ADDENDUM NO. 03

Project: BERLIN TOWN HALL & ANNEX RENOVATIONS

Project No.: 2024-41

Date: JANUARY 02, 2026

SKA-03

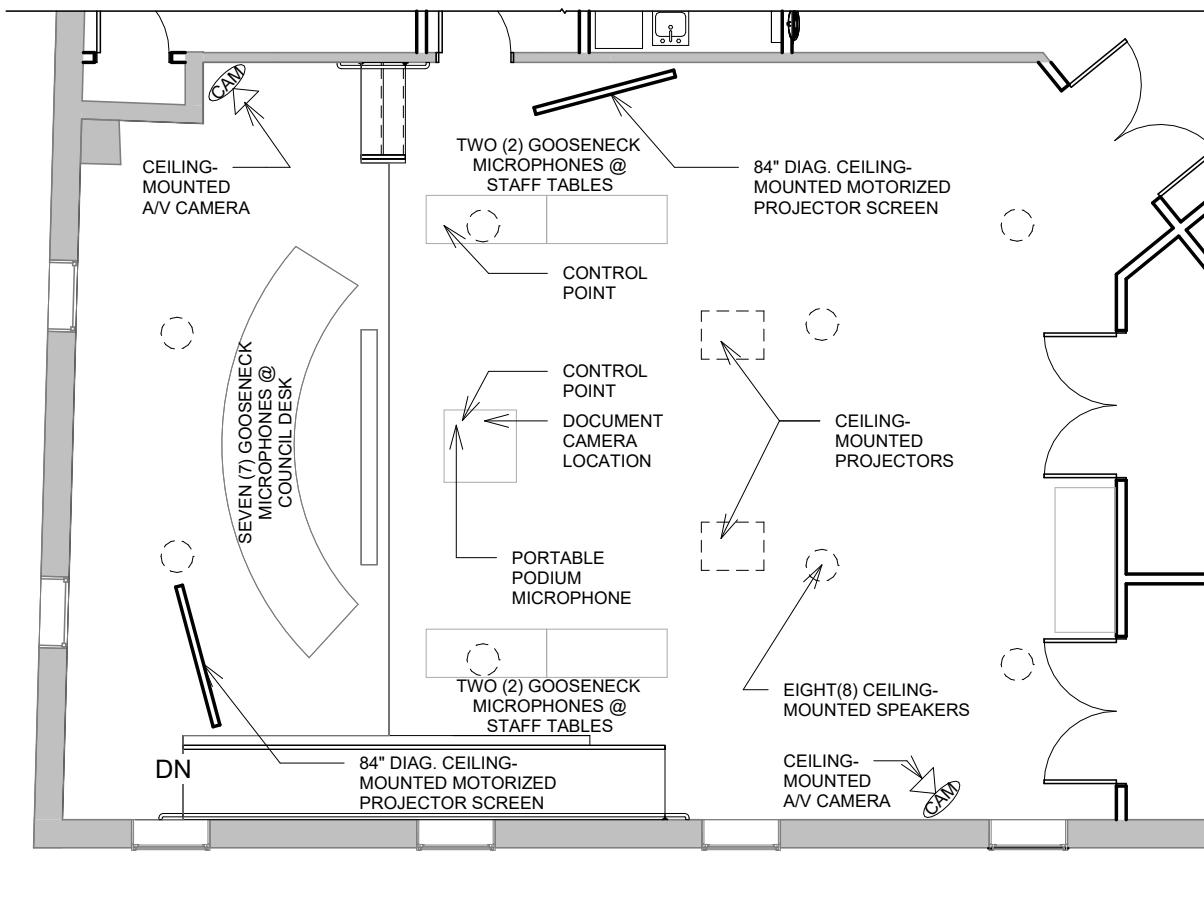
ANSWER: EQPM-07, EQPM-08, AND EQPM-09 ARE INCLUDED IN THE BASE BID SCOPE OF WORK AND NOT TO BE USED WITH A/V BUT AS A 24/7 INFORMATION DISPLAY. A/V CONDUITS TO BE PROVIDED BY CONTRACTOR AS PART OF BASE BID WHERE SHOWN WITH THE EXCEPTION OF COUNCIL CHAMBERS, WHICH IS TO BE INCLUDED IN ALTERNATE #2.
4. **QUESTION:** For Alternate No. 2: Provide a layout of AV scope (devices) listed in Alternate No. 2 for conduit

and AV cabling quantification in Council Chambers. (26 27 26 2.5 calls for 1" A/V conduit but it is not clear where these should go.). Provide specs or model numbers for all devices in Alternate no.2 as a spec has not been provided.

ANSWER: SEE ATTACHED SKETCH SKA-03 COUNCIL CHAMBERS A/V SYSTEM LAYOUT AND NEW SPECIFICATION SECTION 274100 AUDIO-VISUAL SYSTEMS.
